CDM: Recommendation Form for Small Scale Methodologies (version 01)
(To be used for presenting questions/proposals/amendments to the simplified methodologies for small-scale CDM project activity categories)

Date of SSC WG meeting:	15–18 March 2011, SSC WG 30
Title/Subject (give a small title or specify the subject of your submission, maximum 200 characters):	Clarification on the baseline selection for a new cogeneration project activity applying AMS-I.C
Indicative methodology to which your submission relates (refer the items of Appendix B of the Simplified Modalities and Procedures), if applicable.	AMS-I.C “Thermal energy production with or without electricity”
Name of the authors of the query:	Kishor Rathod Institution: ecolutions Carbon India Pvt.Ltd. kishor.rathod@ecolutions.de

Pre - project scenario:

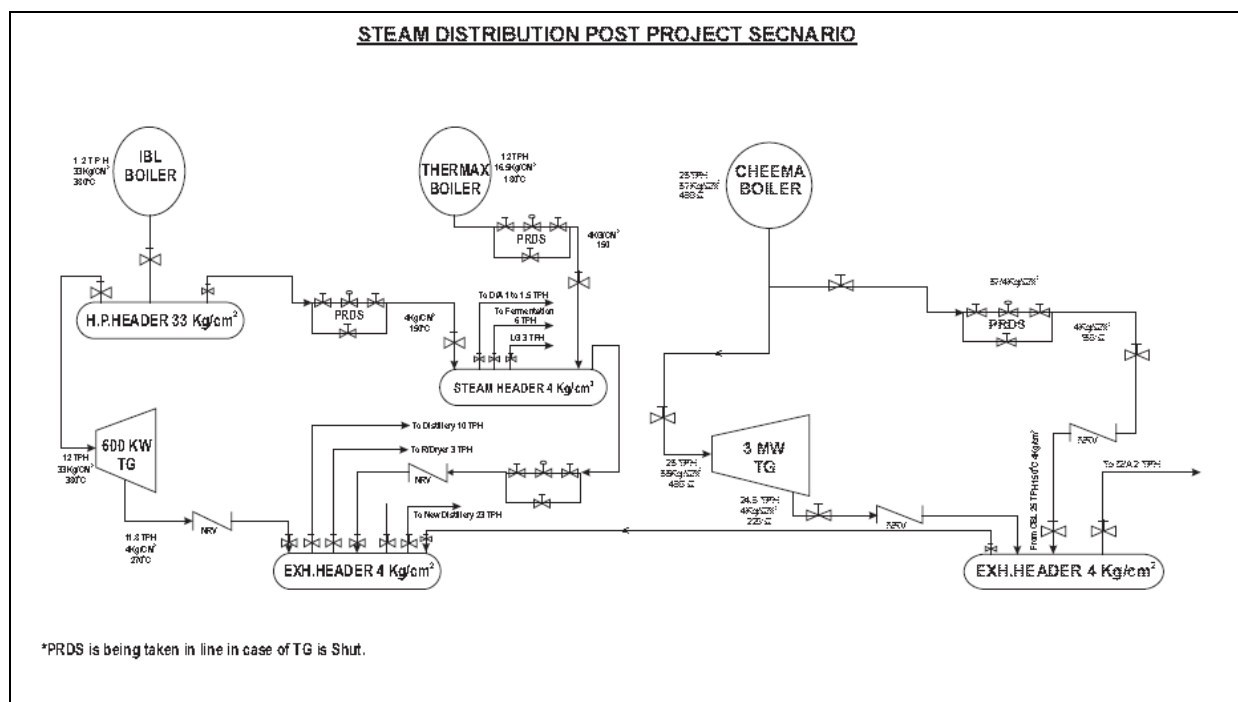
The manufacturing facility's thermal requirement is being met by biomass based boiler (2*12 TPH). The electricity demand is being met by the supply from the Grid & 600 KW biomass based captive cogeneration power plant or DG set (In case of PSEB power cuts).

Therefore, we would like to seek clarifications on following points-

1. Para 15 (e) of AMS I.C version 18 states that-

- (e) Electricity is imported from the grid and/or produced in an on-site captive power plant using fossil fuels (with a possibility of export to the grid); steam/heat is produced from biomass;

In our case –

- Electricity is imported from the grid and also produced in an on-site 0.6 MW captive power plant using biomass (and not fossil fuels with no possibility of export to the grid).
- Steam/heat is produced from biomass.

Hence, is Para 15 (e) of AMS I.C. version 18 applicable/ appropriate for our project activity?

The SSC WG agreed to clarify that the current AMS-I.C does not cover the project activity. The project proponent may consider to submit a request for revision for a new baseline scenario in paragraph 15 (and the corresponding equations for baseline calculation), for example a combination of the existing baseline scenarios stipulated in paragraphs 15 (e) and 15 (g) with some modification.

Since the described project is not currently applicable under AMS-I.C, the group agreed that another query regarding baseline calculations pertaining to the paragraphs of AMS-I.C is not relevant.
